**TB 113A**

## TECHNICAL BULLETIN

**Product :** Maxilift Hydraulic

**Subject :** Introduction of New Safety Gear Activation Plate

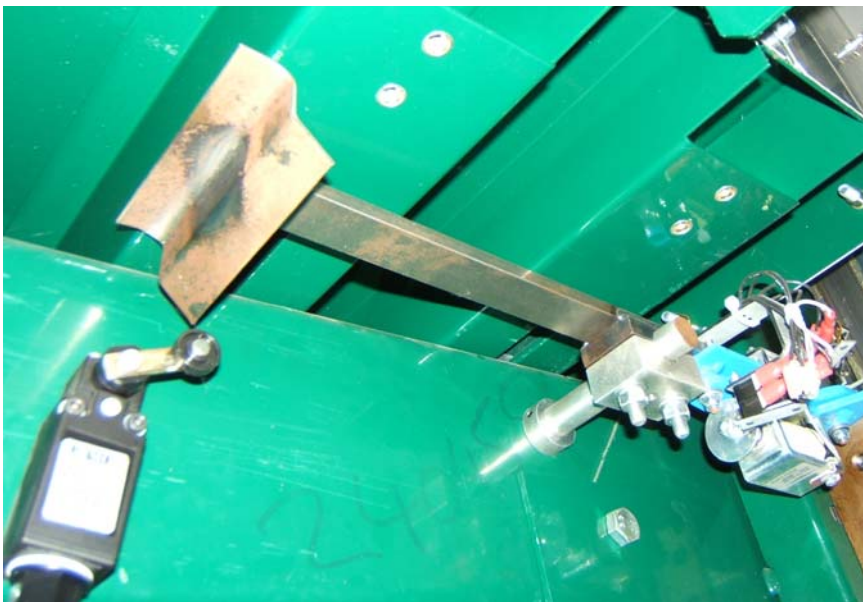
The old arm assembly and arm switch. Located on the outer part under the floor. This is on both sides but only one is used due to what hand the lift is.

Here is how the new safety gear plate looks fitted on the inner part under the floor.

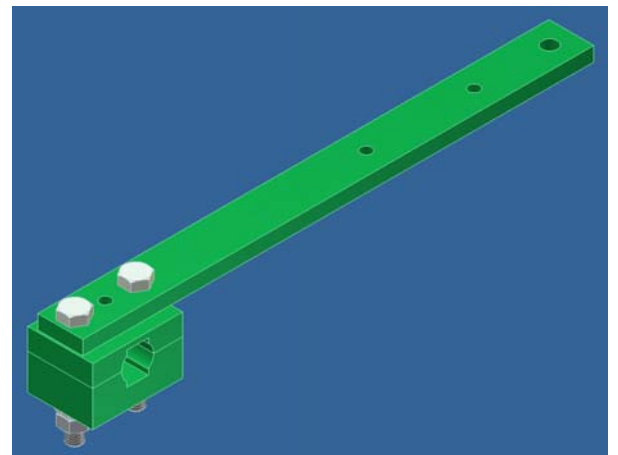
The activation plate acts in the same manor as the arm. When the safety shaft rotates, it moves the plate with it pushing down the 'plunger' on the switch activating it.

The construction of the plate is a simple cut out from sheet metal with a collar inserted and welded onto it.

With the position of the plate, installers and testers have more area of movement around the lift as the old arm will now be removed from the assembly due to it being obsolete.

An issue has been highlighted with the actuation plate design; if the safety gear actuation plate is fitted **after** the car floor is assembled and fitted to the sling assembly then the safety gear actuation plate **will not** pass the halfen fixing holding the floor in place shown below.

To overcome this issue the safety gear **must be** fitted before the car floor is assembled, if this can not be achieved then the floor will have to be loosened and raised so that the actuation plate can pass the halfen bolt and be correctly fitted as above.
